# Neopixel Development PCB R2

PG 11/4/2020

11-4-2020 - (R2) - R2 UPDATES:

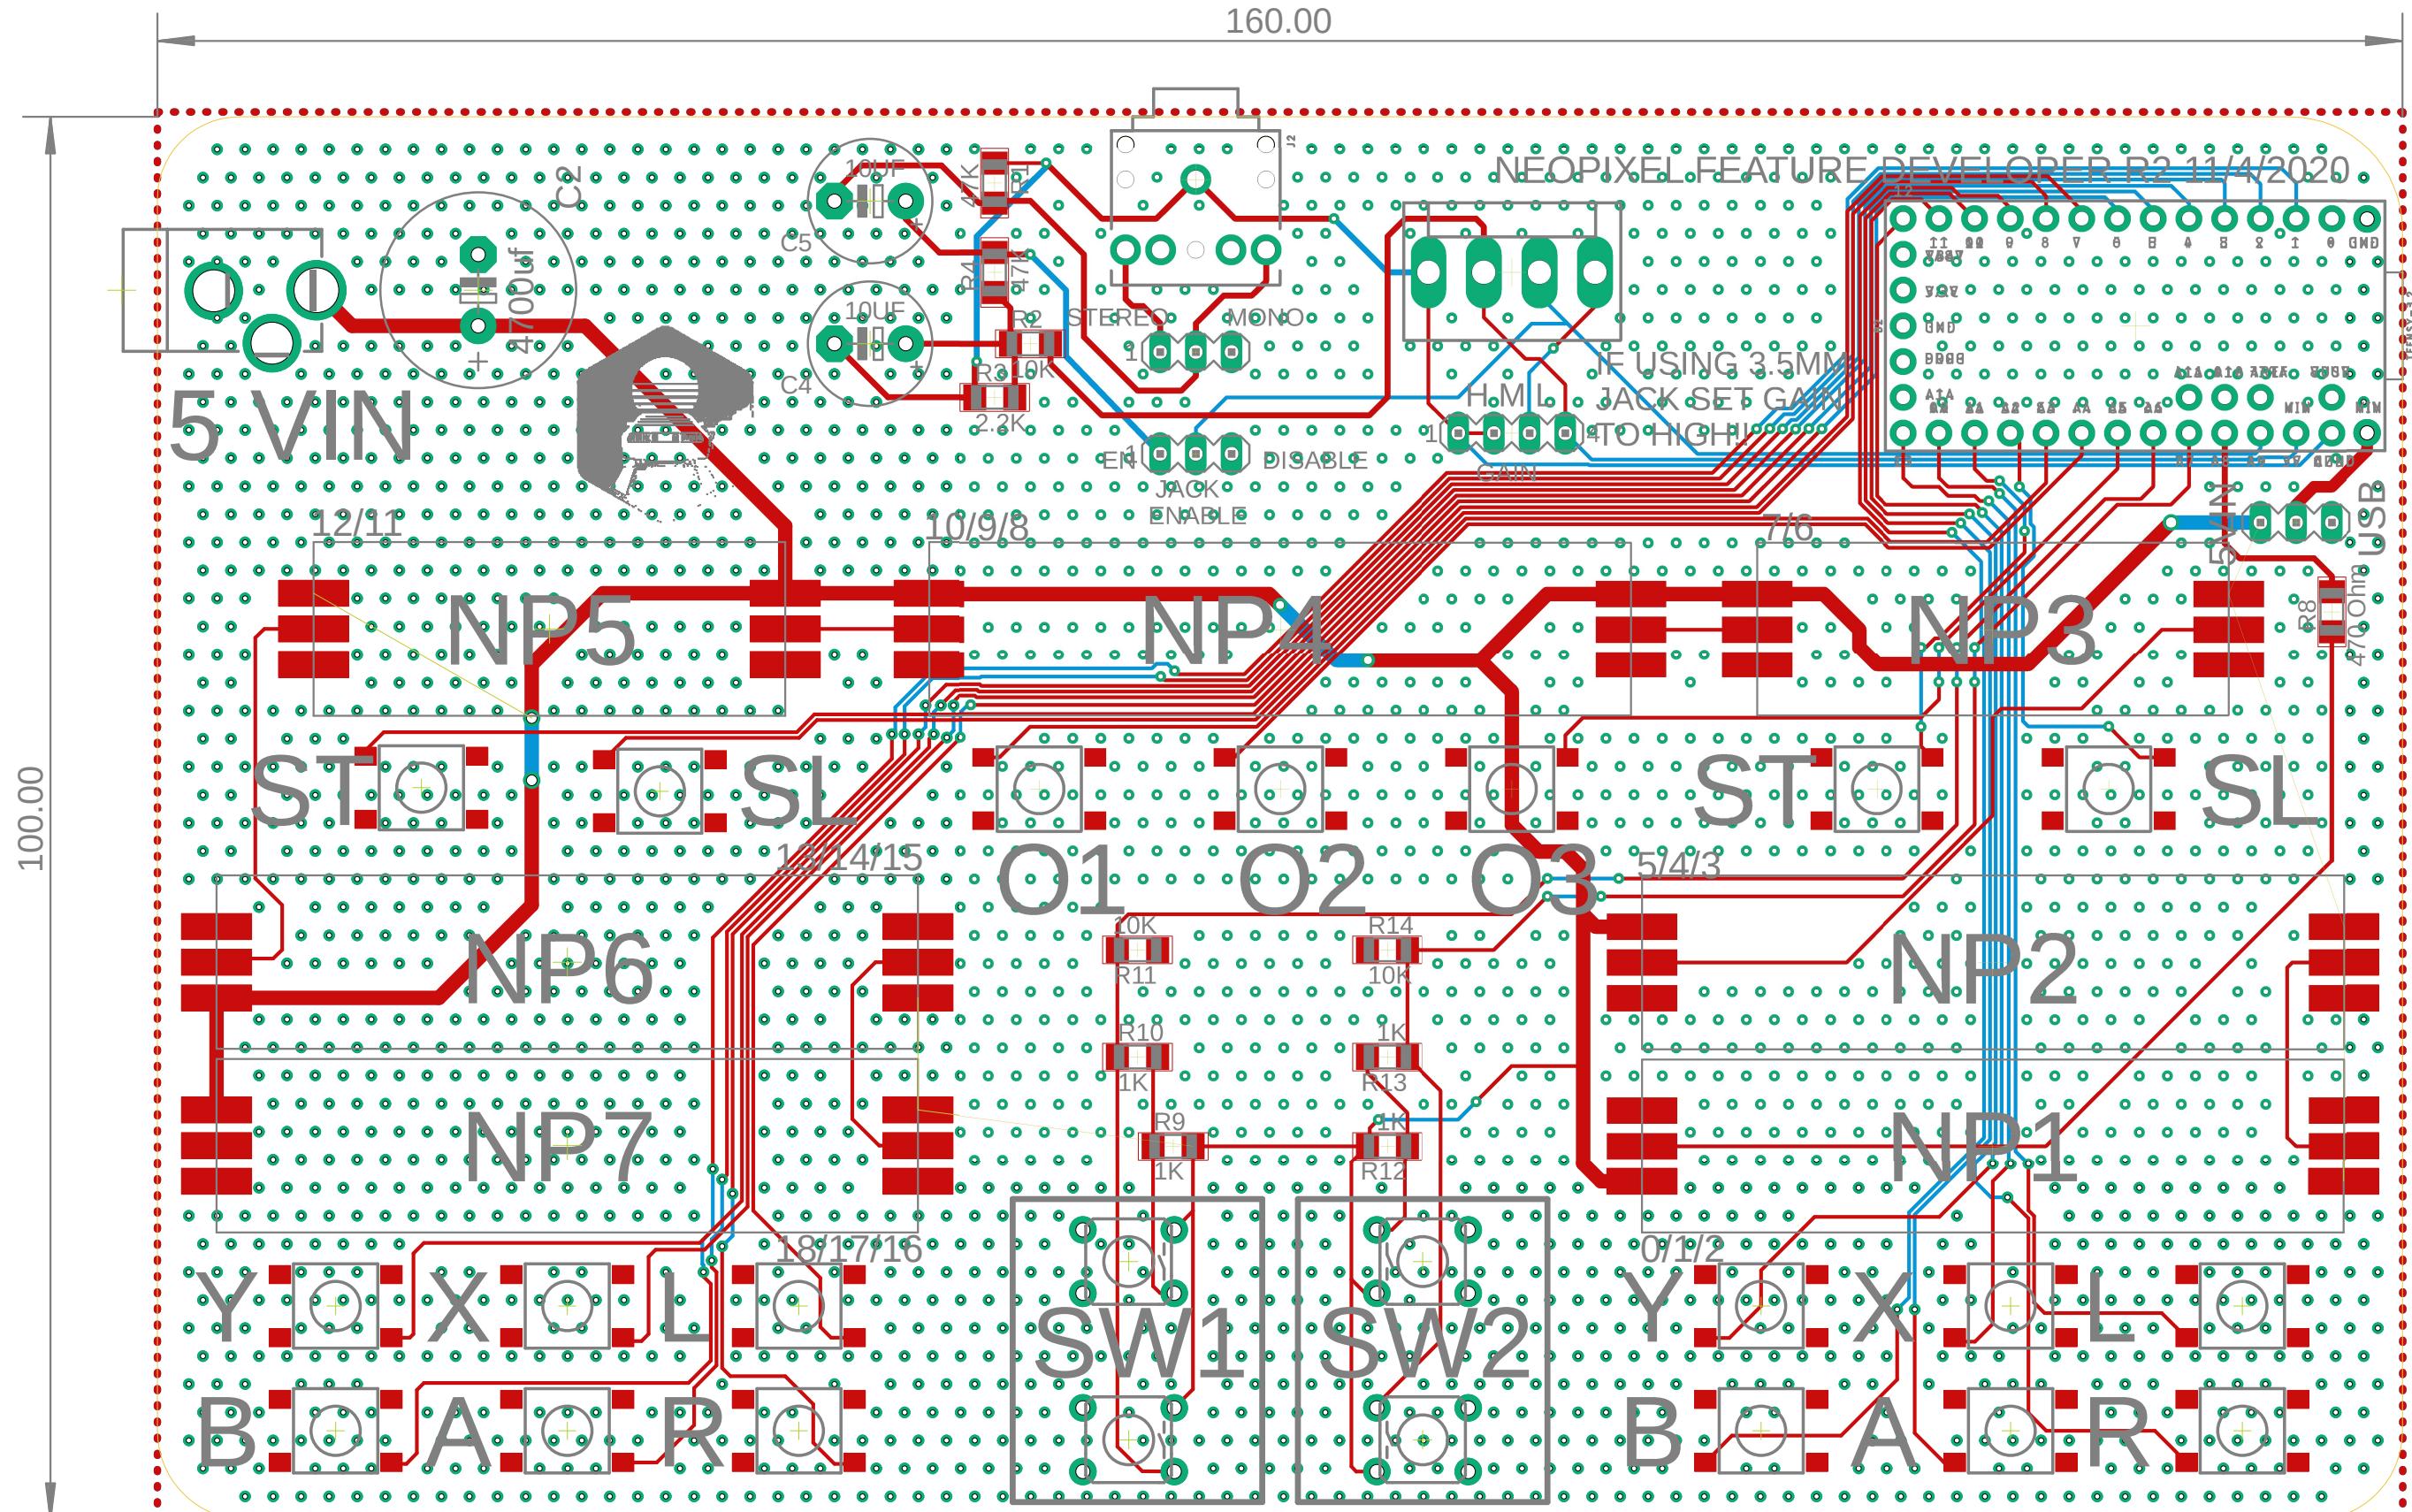
1. MOVED ALL CONTROLS UP ONE PIN ON TEENSY (D0 WOULD NOT REGISTER A ON P1).
2. REMOVED OPT4 AS IT IS NOT USED IN THE DESIGN

11-4-2020 - (R2) - R2 UPDATES:

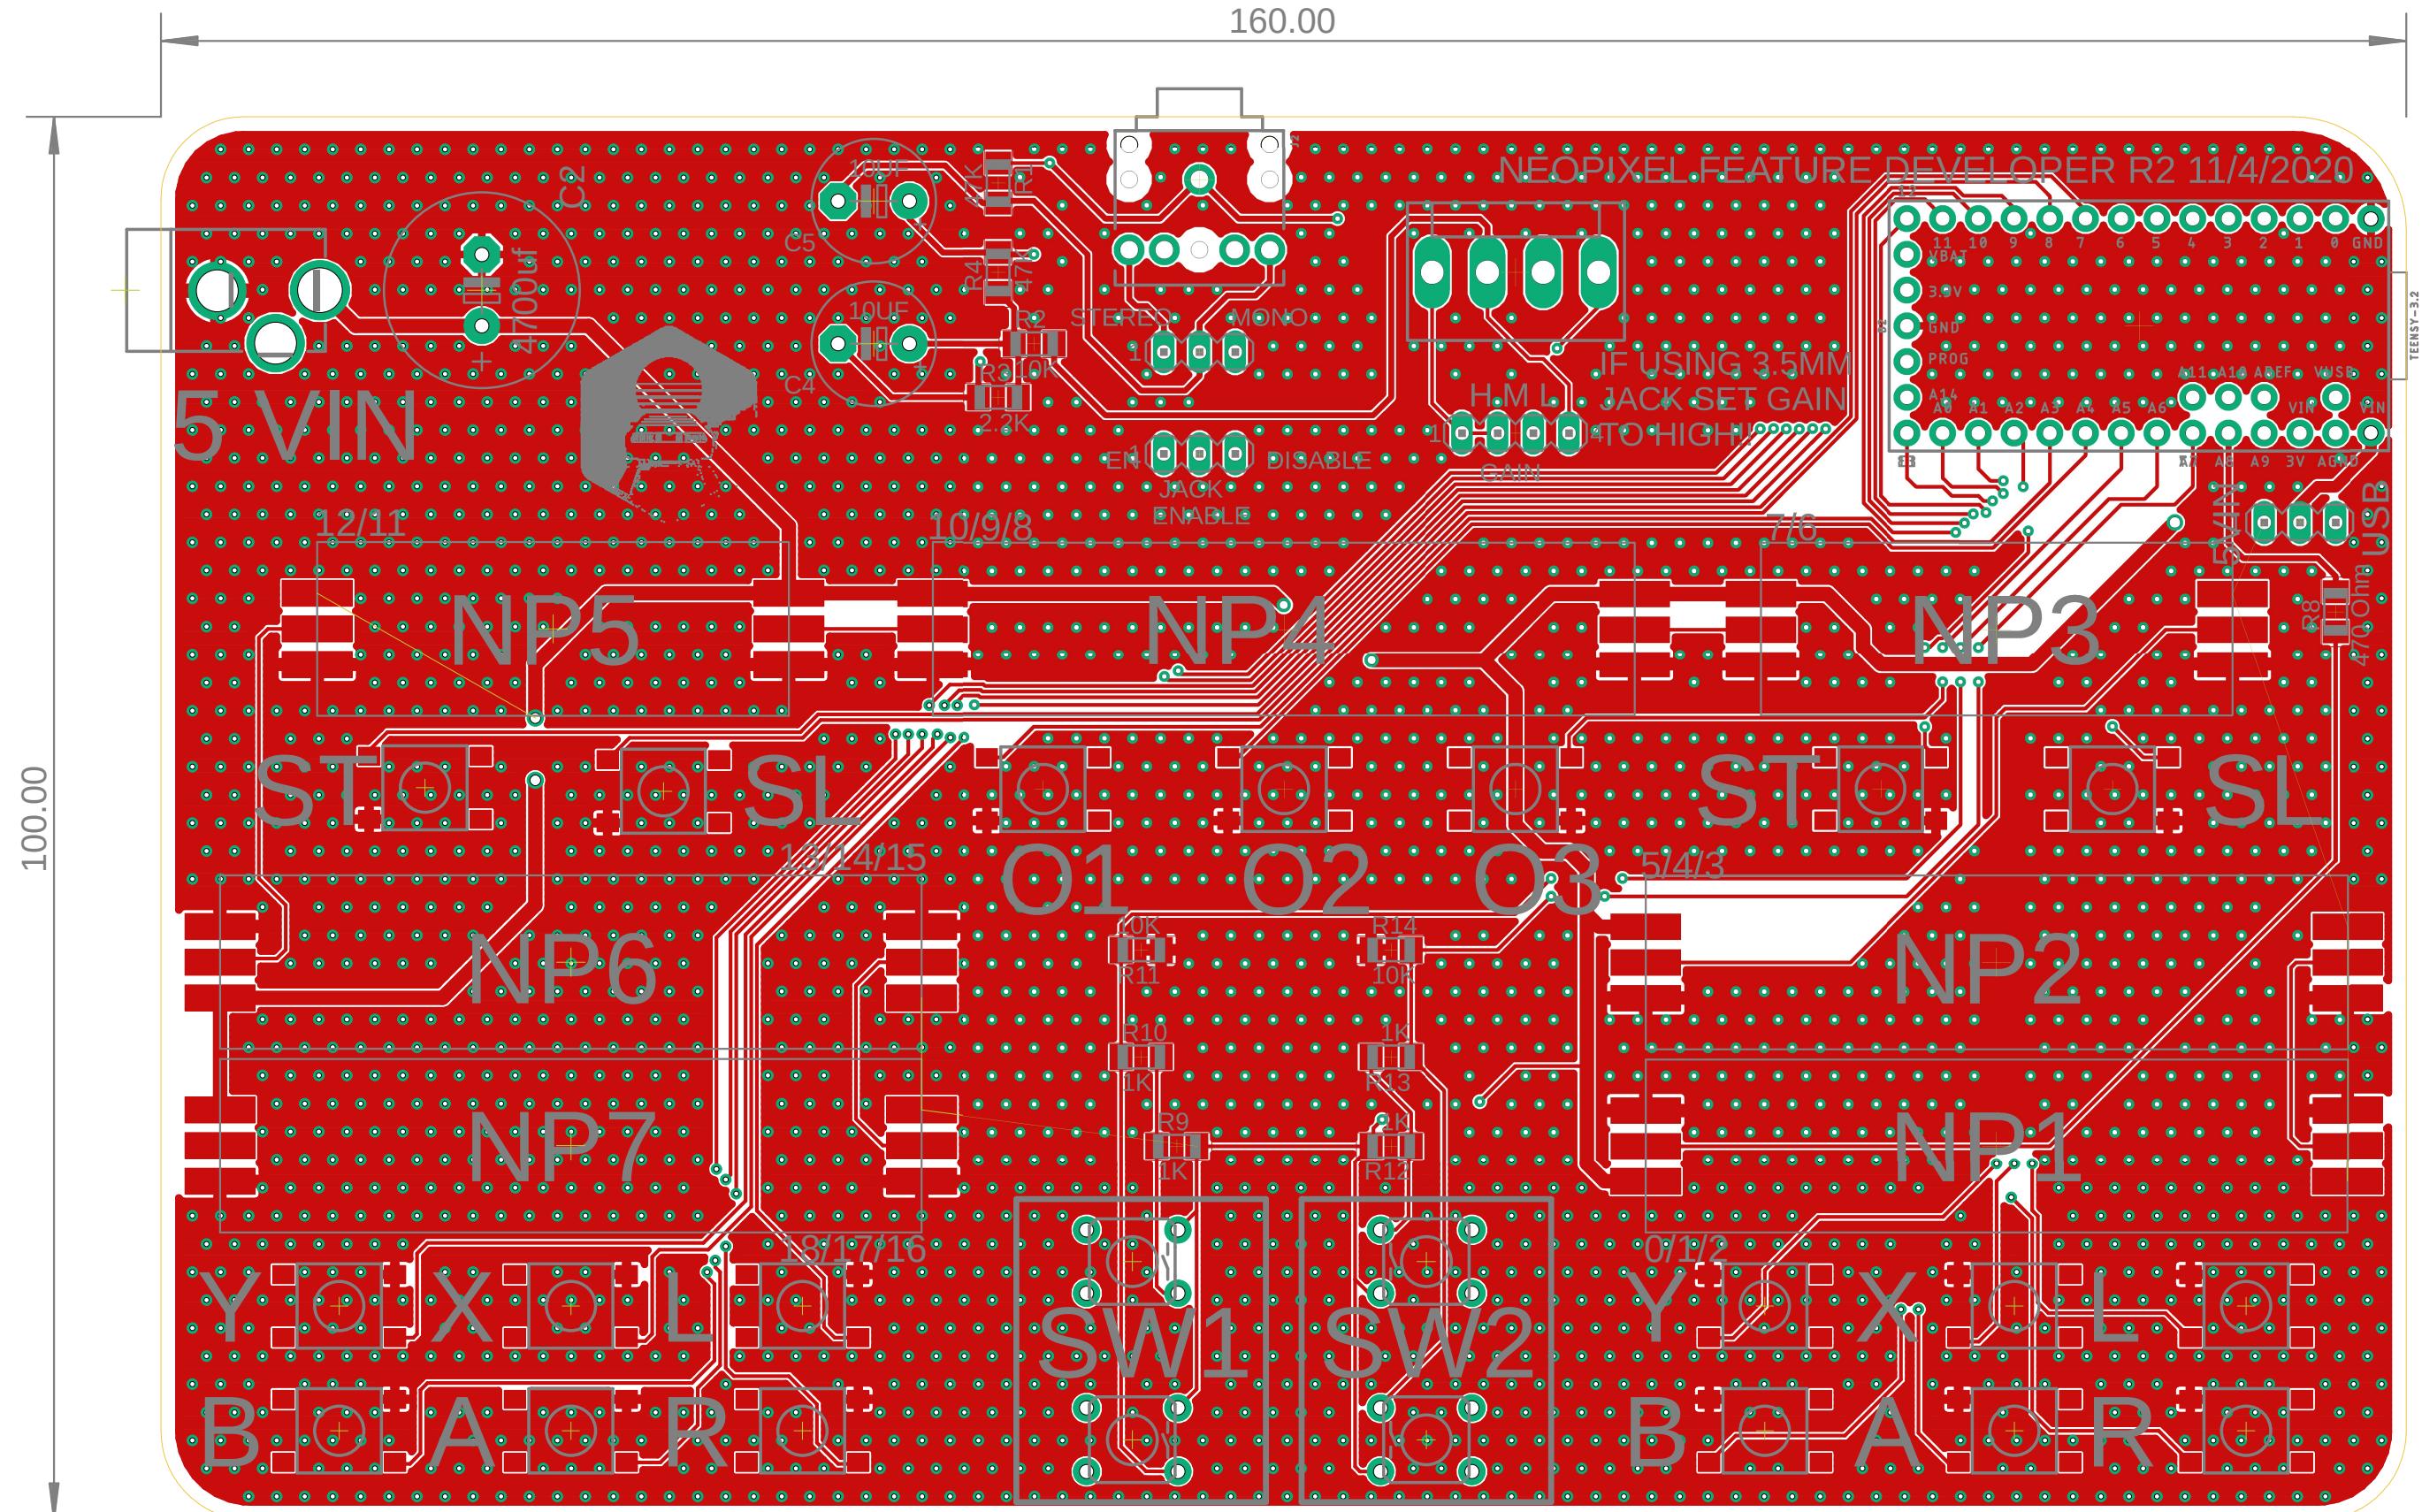
1. MOVED ALL CONTROLS UP ONE PIN ON TEENSY  
(D0 WOULD NOT REGISTER A ON P1).
2. REMOVED OPT4 AS IT IS NOT USED IN THE DESIGN
3. ALL INPUT TRACES RERUN, STITCHING RERUN TO MATCH NEW TRACES
4. ADDED VIA STITCHING TO GND PLANE

11-4-2020 - (R2) - R2 UPDATES

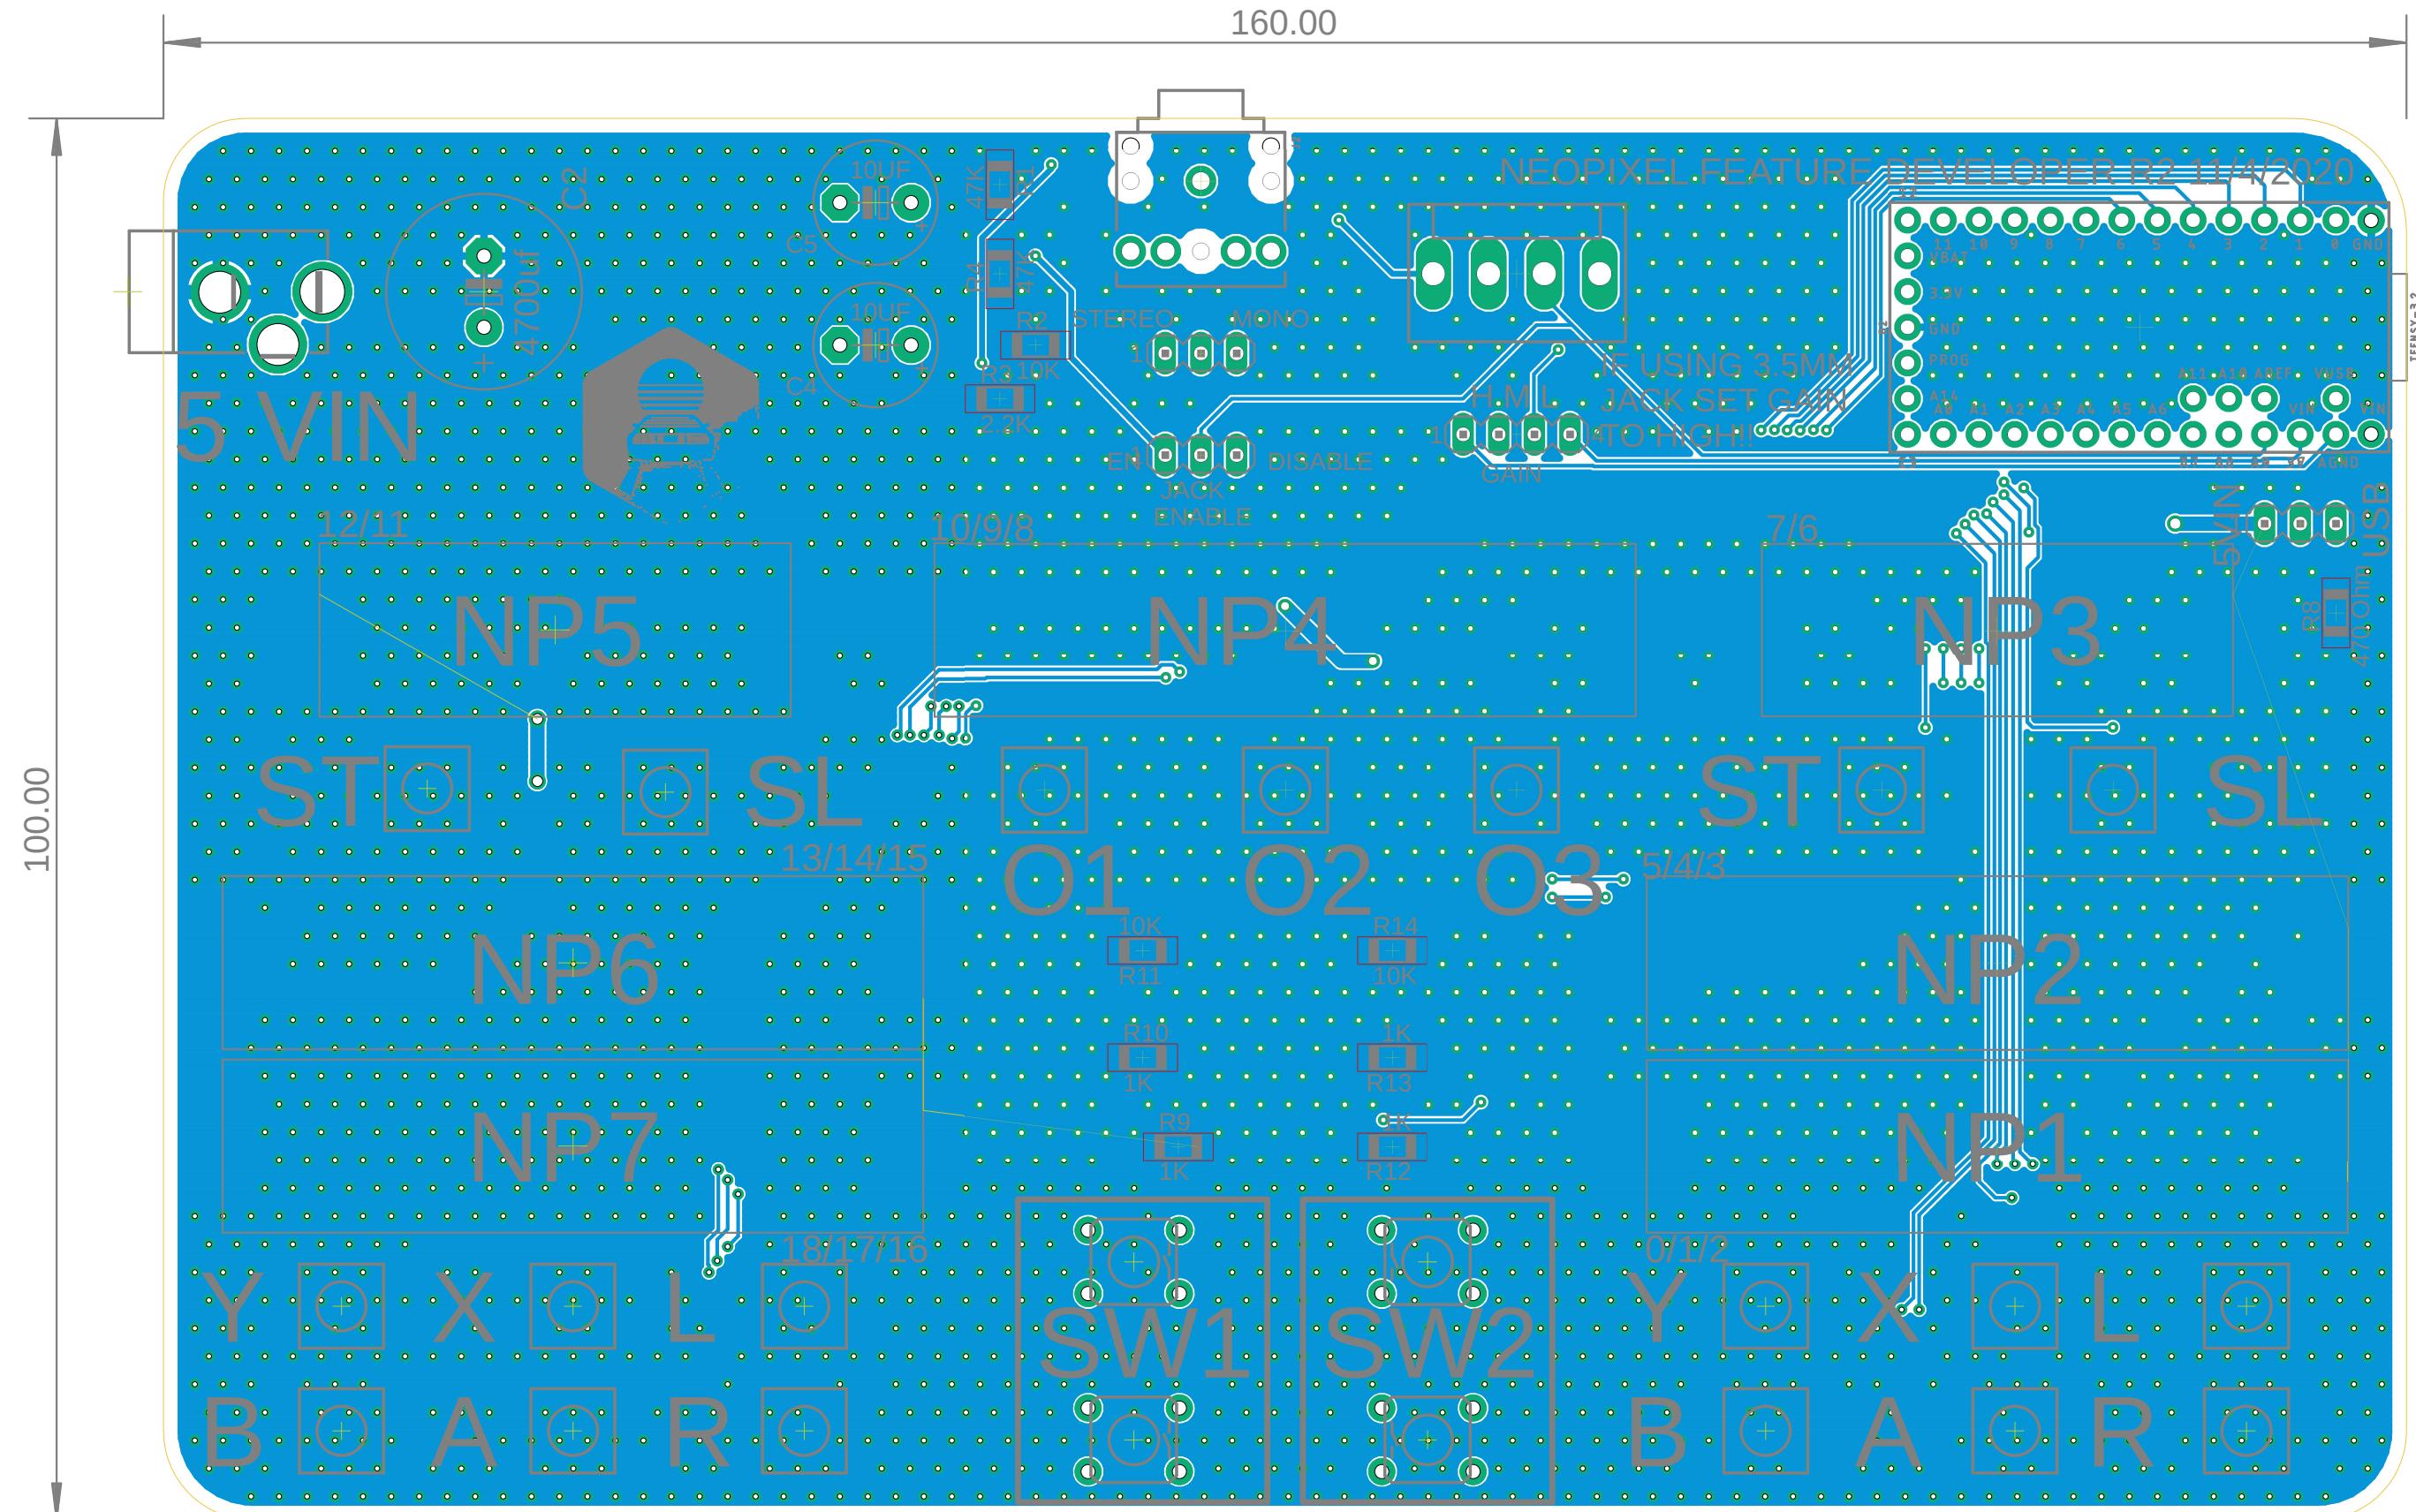
1. MOVED ALL CONTROLS UP ONE PIN ON TEENSY  
(D0 WOULD NOT REGISTER A ON P1).
  2. REMOVED OPT4 AS IT IS NOT USED IN THE DESIGN
  3. ALL INPUT TRACES RERUN, STITCHING RERUN TO MATCH NEW TRACES
  4. ADDED VIA STITCHING TO GND PLANE
